Prairie Island Nuclear Generating Plant

**License Amendment Request Dated October 25, 1996**  
**Incorporation of Appendix J, Option B Containment Leak Testing Requirements**

This amendment request proposes a change to Technical Specification (TS) 4.4.A, "Containment Leakage Tests," the addition of TS.6.5.J, "Containment Leakage Rate Testing Program," and a change to the Bases to the Technical Specifications section B.4.4, "Containment System Tests."

## CONTAINMENT VACUUM BREAKER INFORMATION

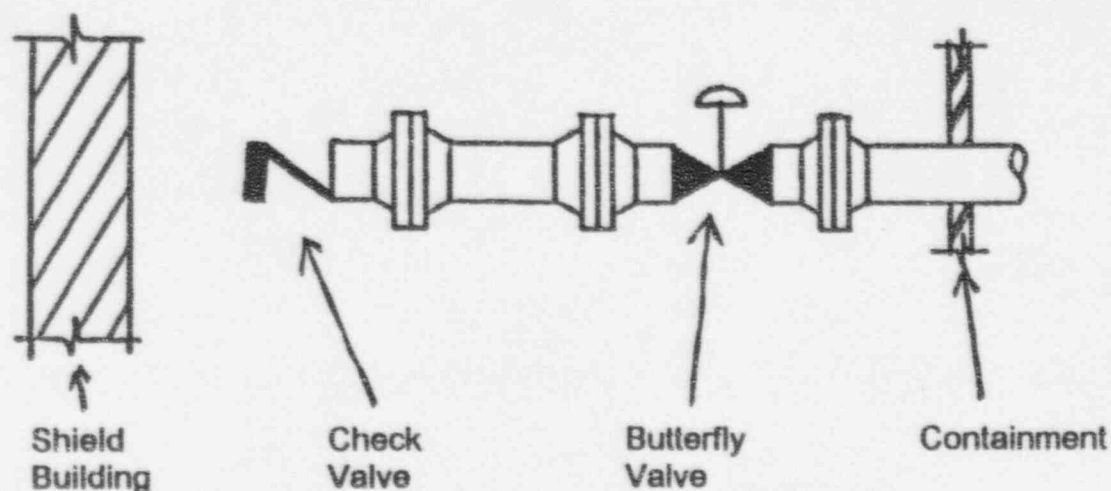
Note that we intend to test the containment vacuum breakers with test intervals allowed up to 60 months based on continued satisfactory performance. This contrasts with our treatment of containment purge and vent valves which will be tested with intervals not to exceed 30 months in accordance with Regulatory Guide 1.163. Attachment 1 provides a discussion of our position regarding the test intervals.

NRC Regulatory Guide 1.163 stipulates that test intervals for containment purge and vent valves should be limited to 30 months with consideration given to operating experience and safety significance. This test interval is shorter than that allowed for other containment penetration valves; the shorter test interval is based on the seat material (resilient seal), the large size of the valves, and the potential unfiltered leak path. Similar to the purge and vent valves, the containment vacuum breaker assembly valves at the Prairie Island Nuclear Generating Plant have resilient seal seat material and are relatively large valves. The following discussion justifies testing the containment vacuum breaker valve assemblies at intervals allowed for other containment isolation valves; i.e., up to 60 months based on continued satisfactory performance.

The vacuum breaker assemblies have an excellent performance history; the measured leakage over the past 10 years is shown on the next page. The administrative leakage limit for the vacuum breaker assembly is 6000 cc/min; as shown, most of the results are less than 10% of this desired value. The seals are designed to last 40 years. The results shown on the next page indicate no definitive trend of seal degradation. Maintenance on the seals is based on testing results. No maintenance has been required on the seals in either unit since plant startup.

The acceptance criteria for seal leakage is based on the overall leakage ( $L_a$ ) to the shield building annulus. The  $L_a$ , assumed in the off-site dose analysis, to the annulus is 144,480 cc/min at a maximum design differential pressure of 46 psi. During an accident, leakage to the annulus is recirculated and filtered by high efficiency HEPA and charcoal filters prior to release. In addition to the vacuum breaker assemblies, the other penetrations which could leak to the annulus are electrical penetrations, hydrogen control valves, and hot piping bellows. These penetrations have, historically, had small leak rates. A review of the last ten years of testing results shows that the average total leakage to the annulus was less than 5,000 cc/min at maximum design differential pressure. This provides substantial margin for an unexpected increase in leakage through a vacuum breaker assembly.

Therefore, based on the performance history of these valve assemblies and the minimal safety significance associated with the assemblies, it is considered acceptable to test these assemblies at increased intervals allowed by Regulatory Guide 1.163 (up to 60 months).
